ATTACHMENT A

MARKUP TECHNICAL SPECIFICATION PAGES  
FOR FACILITY OPERATING LICENSES  
DPR-19 AND DPR-25

REVISED TECHNICAL SPECIFICATION PAGES  
FOR FACILITY OPERATING LICENSES  
DPR-19 AND DPR-25

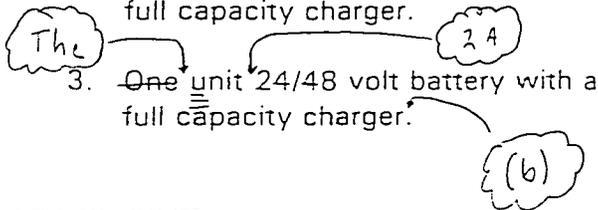
With any of the above required station batteries and/or associated charger(s) inoperable, suspend CORE ALTERATIONS, suspend handling of irradiated fuel in the secondary containment, and suspend operations with a potential for draining the reactor vessel.

1. One station 250 volt battery with a full capacity charger.
2. One station 125 volt battery with a full capacity charger.
3. The Unit 2A 24/48 volt battery with a full capacity charger.<sup>(b)</sup>
